SERVICE BULLETIN

Pub. No. SB18-200
Issued: December 72018
(SBR Ref. B2018-214)

Subject:	Parts Change Information: New PLATE BMPR SD for BRZ Front Bumper
Applicable part category in Service Manual:	Body & Electrical/WIRING SYSTEM > EXTERIOR/INTERIOR TRIM > Front Bumper
Applicable Parts name in Subaru Parts System:	PLATE BMPR SD
Foreword:	<p>This service bulletin is to inform you the availability of new part, PLATE BMPR SD (metal plate) for BRZ Front Bumper as countermeasure of side splitting part coming loose.</p> <p>For the repairs, use the PLATE BMPR SD (metal plate) as a reinforcing part, and follows the work procedure provided on this Service Bulletin.</p>

2-1 Details of affected area

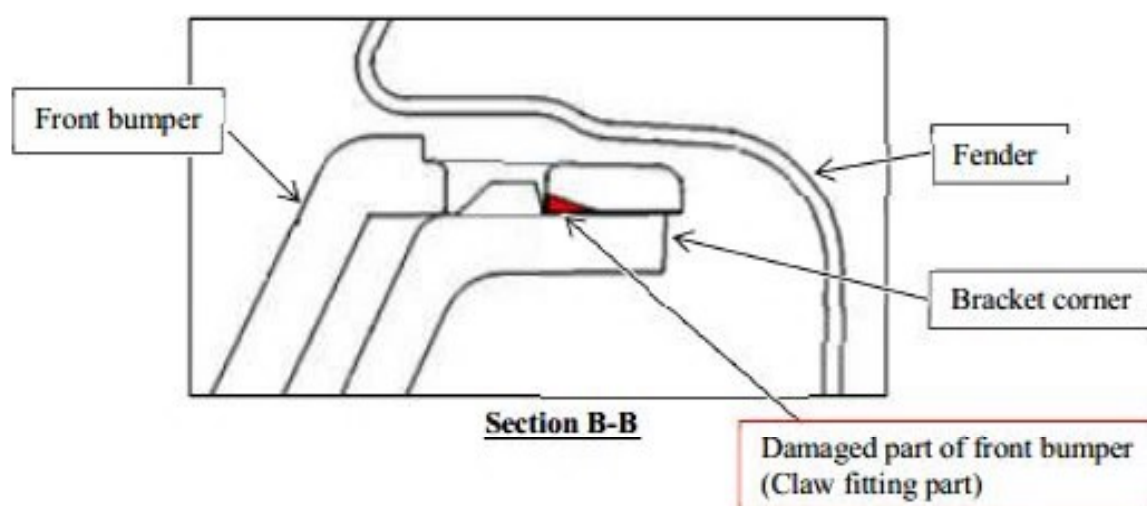
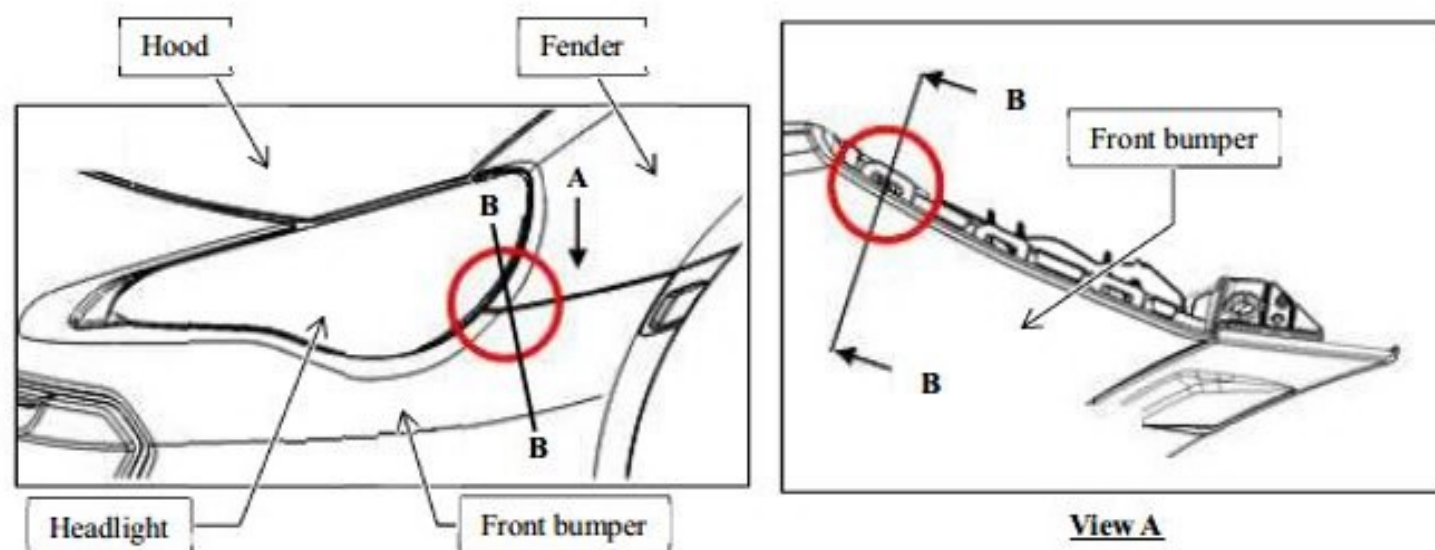
Symptom	Details of Symptom and Improvement
On some certain vehicles, the side view of the front bumper may come loose.	<p>Details of Symptom, Cause: The side part of the front bumper may come loose. This is because the claw of the front bumper rubs against the bracket corner and damages it, resulting in the poor fitting force.</p> <p>Improvement Content: Please install the PLATE BMPR SD (metal plate), which has been newly set as a reinforcing part, to reinforce the affected area. For the working procedure, please refer to this service bulletin.</p>

View A

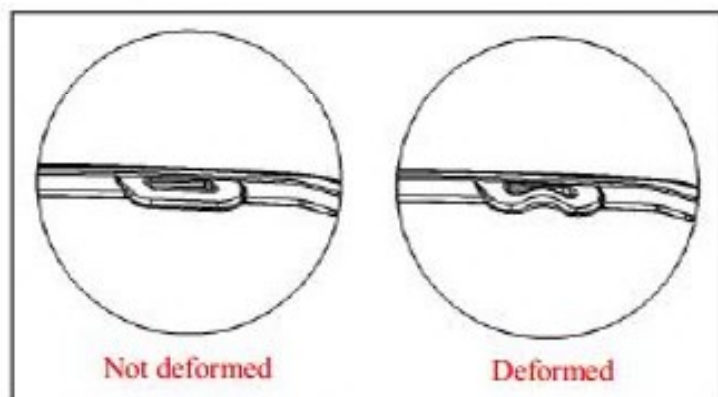
- There is no crack, whitening or damage (excluding damage of the claw fitting part due to the rubbing) on the affected area.
- There is no deformation on the claw fitting part. (Refer to View C)
- The dimension is within the reference value range (4.5 mm or less). (Refer to Section E-E)

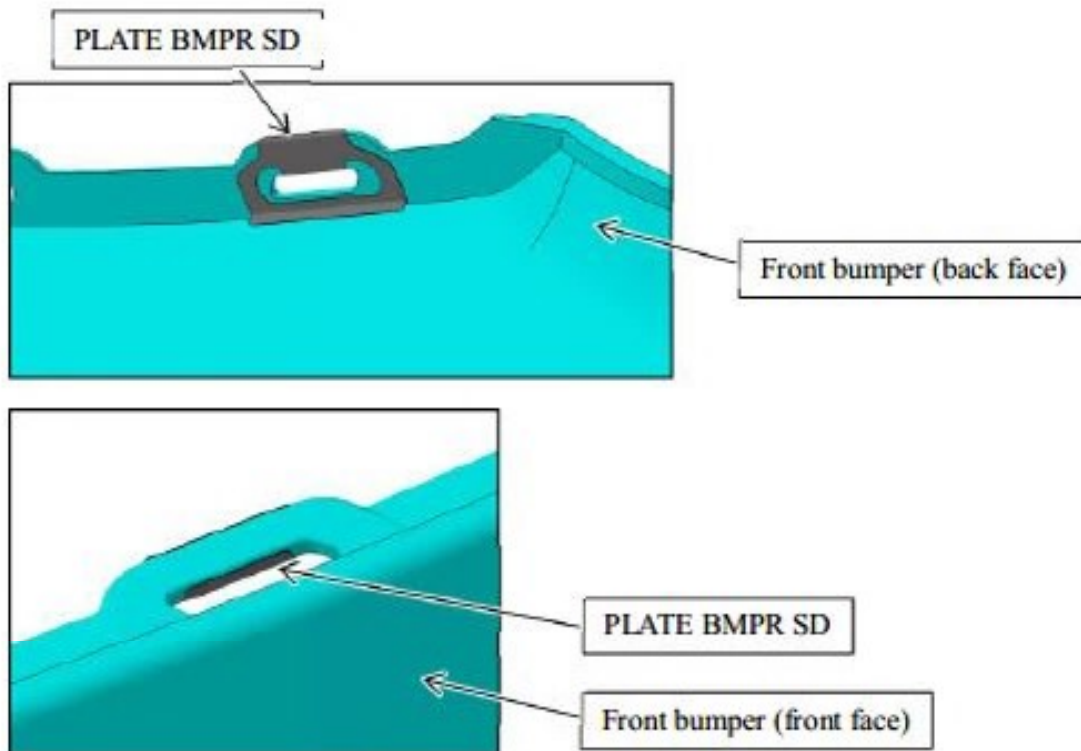
5. Install the PLATE BMPR SD on the back face (RH, LH) of the front bumper.

If there is a burr on the front bumper and it is difficult to install the PLATE BMPR SD, remove the burr on the front bumper using a metal file, etc. Be careful not to file other parts than the burr.
